UPPER UWCHLAN TOWNSHIP  
PLANNING COMMISSION  
AGENDA

RE: QBD Ventures  
Preliminary/Final Land Development Plan  
Upper Uwchlan

**RE: QBD VENTURES – 164 BYERS ROAD – LANDSCAPE WAIVERS  
UPPER UWCHLAN TOWNSHIP, CHESTER COUNTY, PA  
PRELIMINARY LAND DEVELOPMENT PLAN, DATED 09-28-2023**

Reference: QBD Ventures  
Preliminary/Final Land Development Plan  
Upper Uwchlan Township, Chester County, PA

### RETAINING WALL DETAIL (TYPICAL)

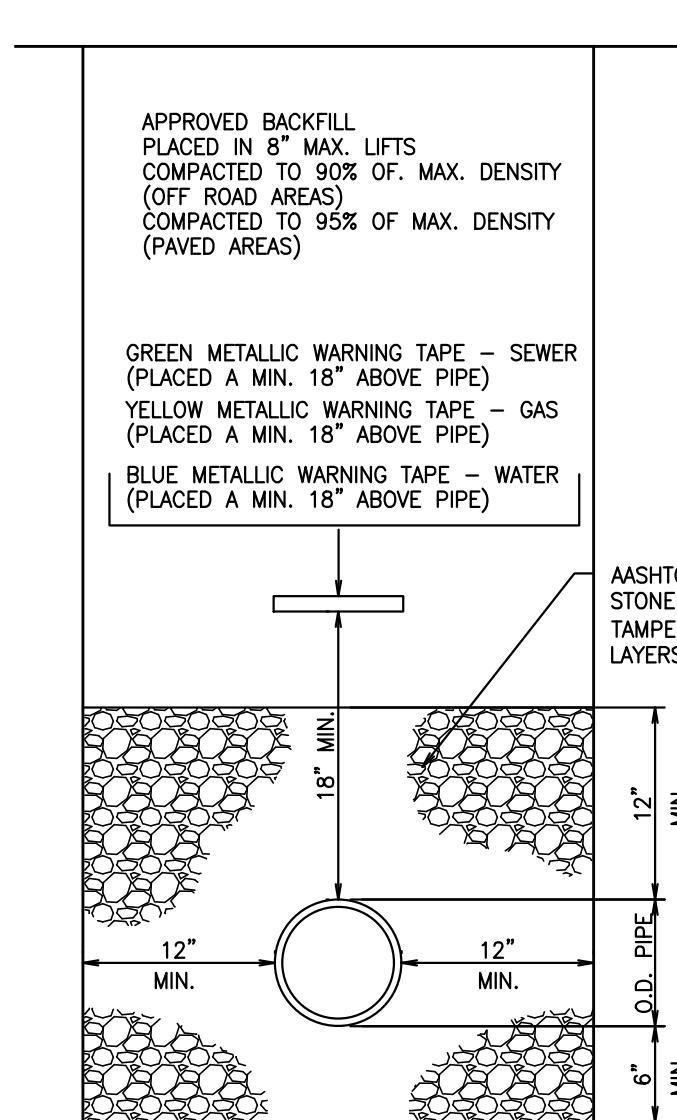
1. *The Applicant should clarify how the retaining wall will be constructed without impacting the adjacent properties. The proposed retaining wall is located approximately one (1) foot from the property line and is immediately adjacent to several existing trees and an existing fence line.*

THE CONTRACTOR SHALL SUBMIT SHOP DRAWINGS FOR THE CONCRETE BLOCK RETAINING WALL TO THE TOWNSHIP FOR APPROVAL PRIOR TO WALL INSTALLATION.

**A construction detail should be provided on the plan. Shop drawings for wall must be provided prior to construction.**

### HDPE STORM PIPE TRENCH DETAIL

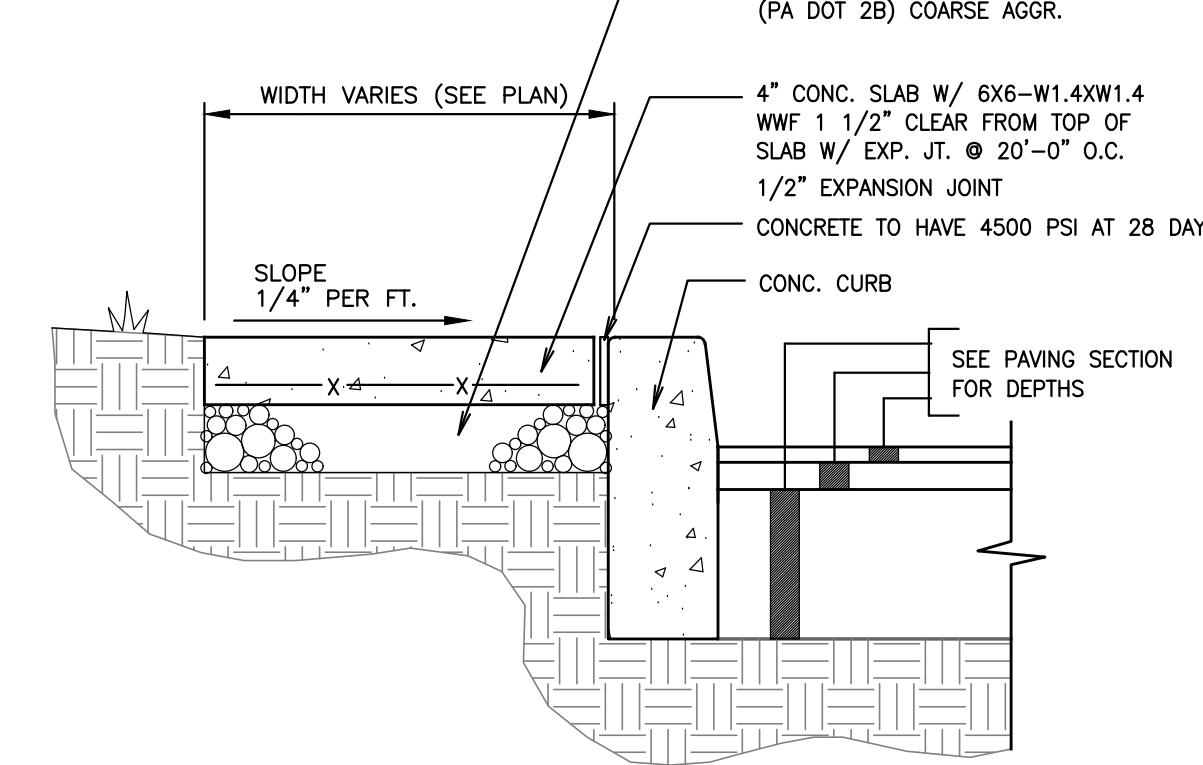
2. *A detail should be provided for pipe trench restoration in both paved and unpaved areas.*

**A detail has been provided as requested. However, the stormpipe detail should be revised to indicate there is to be a minimum of 12" of 2A stone provided above the top of the pipe under paved areas.**

# PRELIMINARY LANDSCAPE PLAN

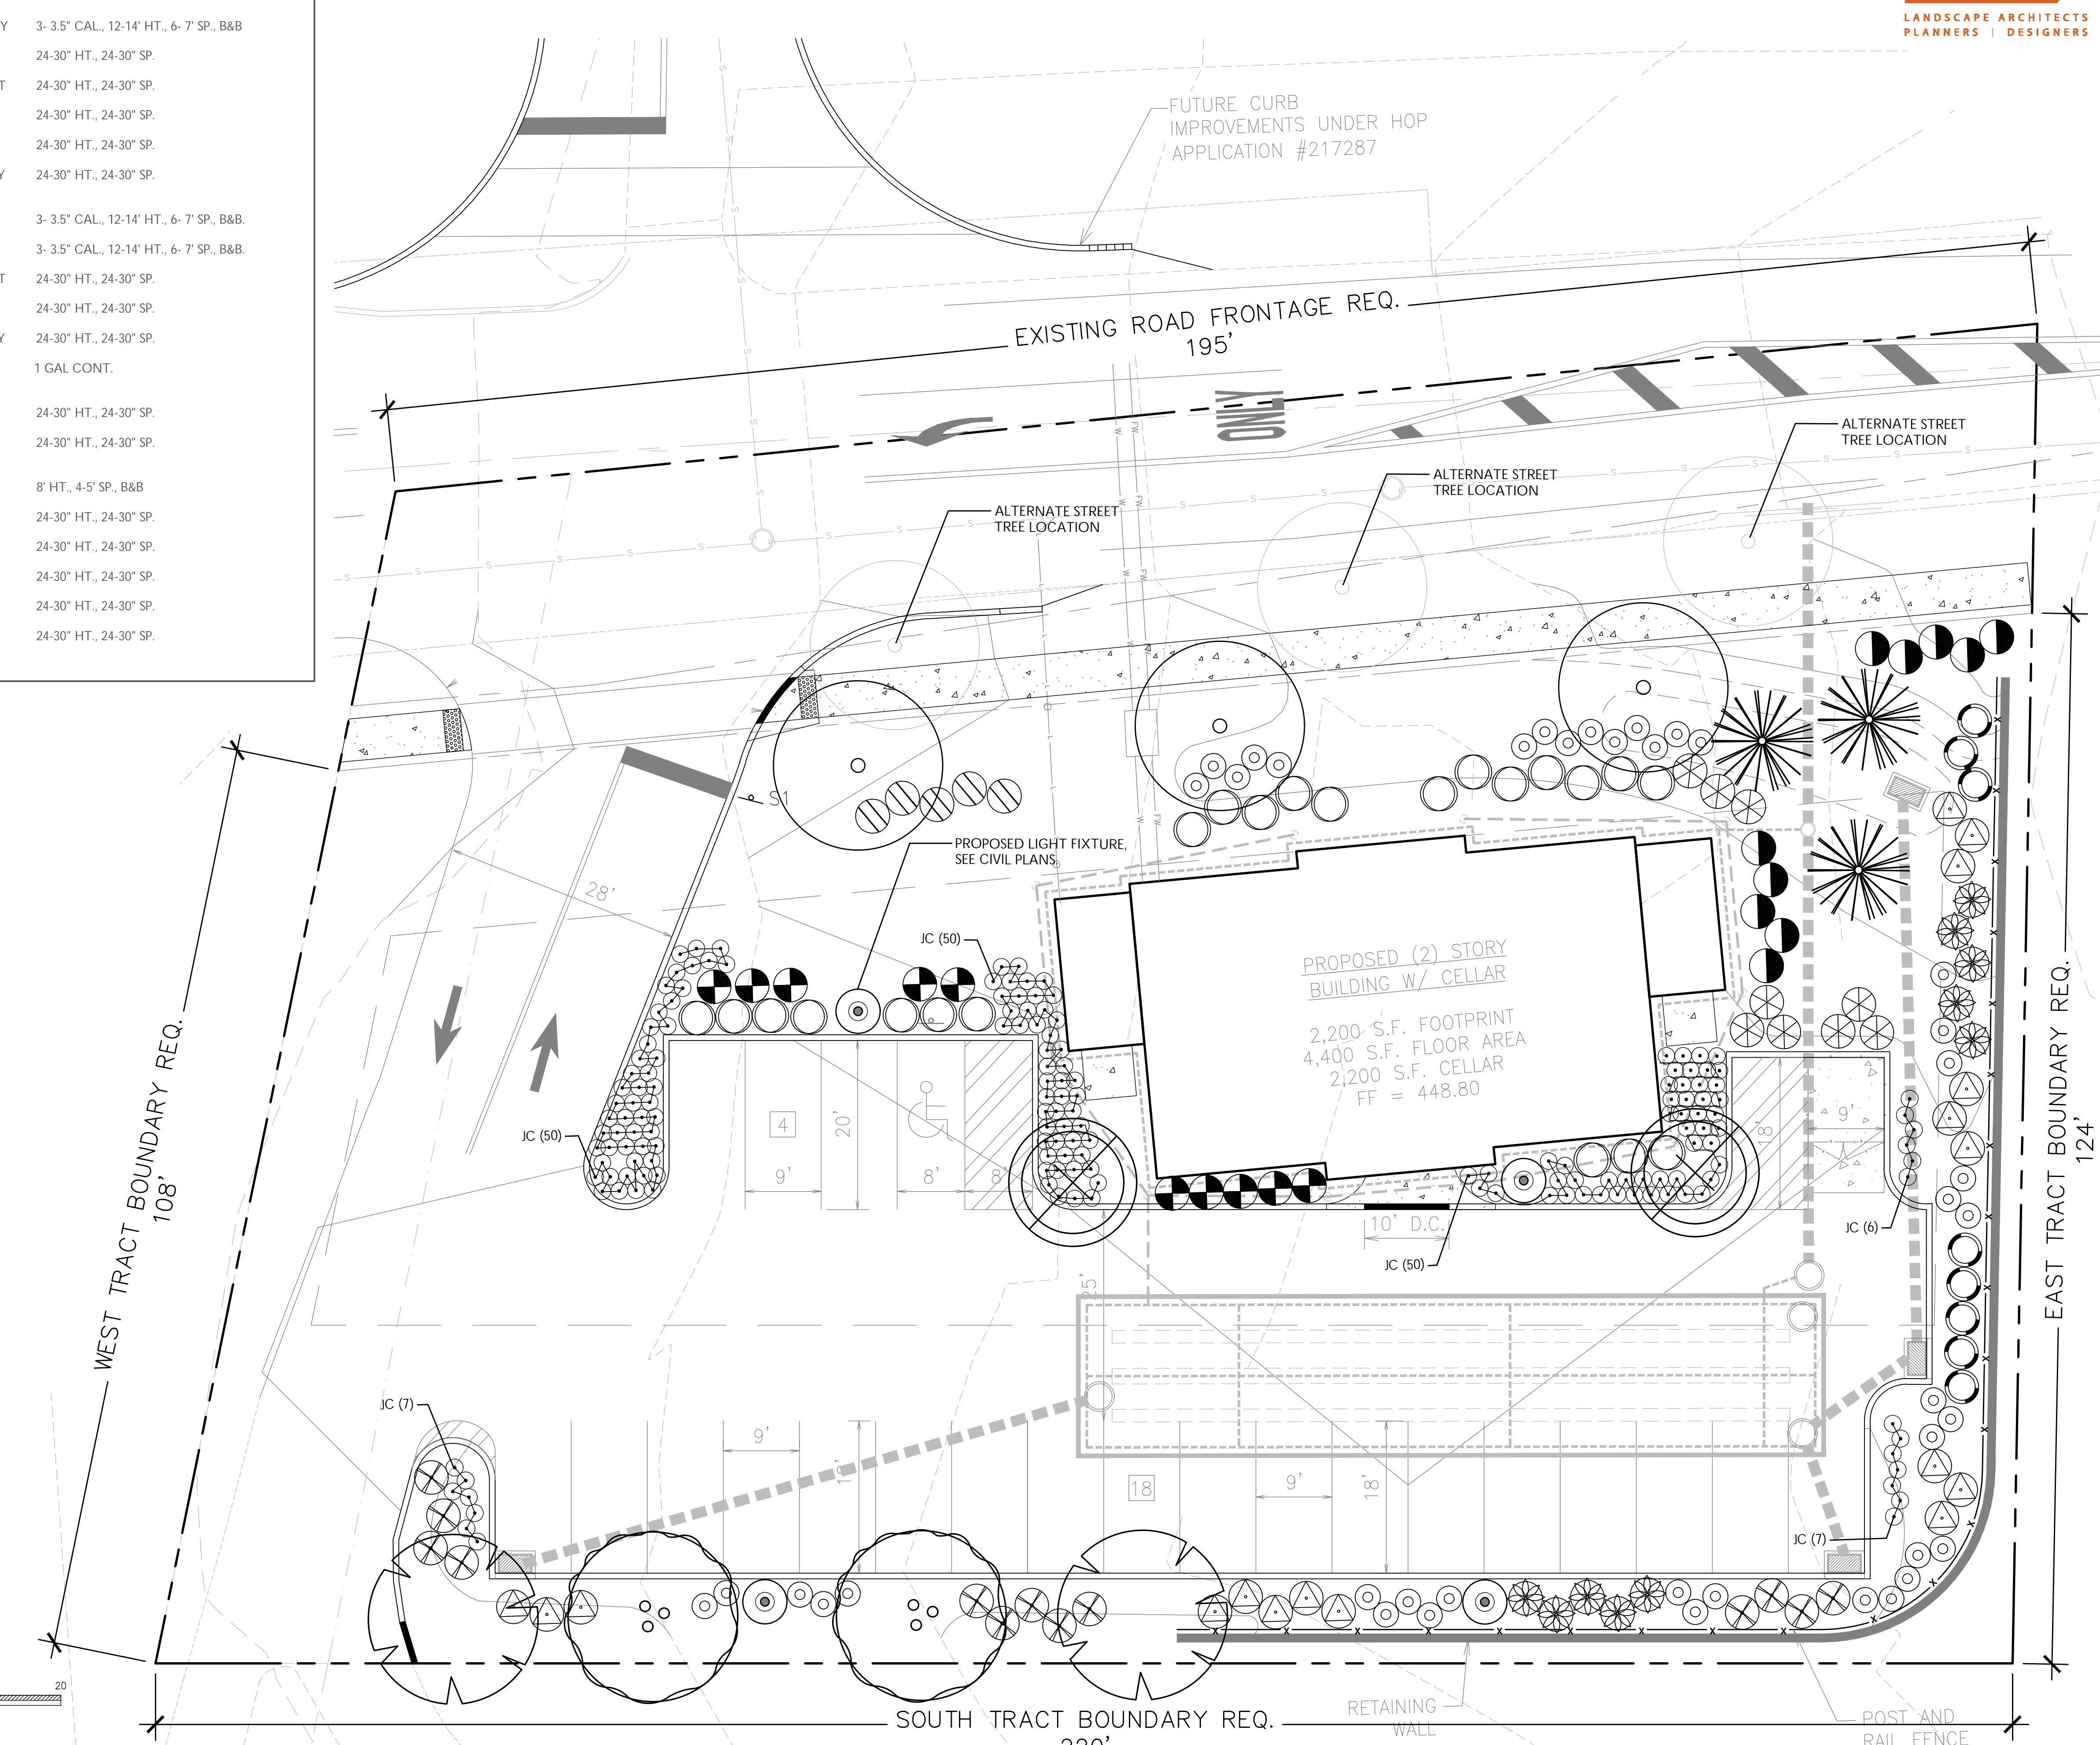
- The Planning Commission did not recommend approving the requested landscape waiver and wanted to see more trees on the property. Also, the chairperson did not like the placement of the pin oak that was shown adjacent to the driveway out, and would like it moved.

- 2) As far as relocating the pin oak tree shown at the driveway exit goes, we have directed our Landscape Architect to make the requested change, with said change shown on the attached revised Landscape Plan.

Based upon the above, I would appreciate it if the Planning Commission would reconsider our request for their granting of Preliminary/Final Approval of the Land Development Plans submitted to them at their 9/14/23 meeting as currently revised, i.e. recommend approval of the attached revised Landscape Plan as herewith submitted.
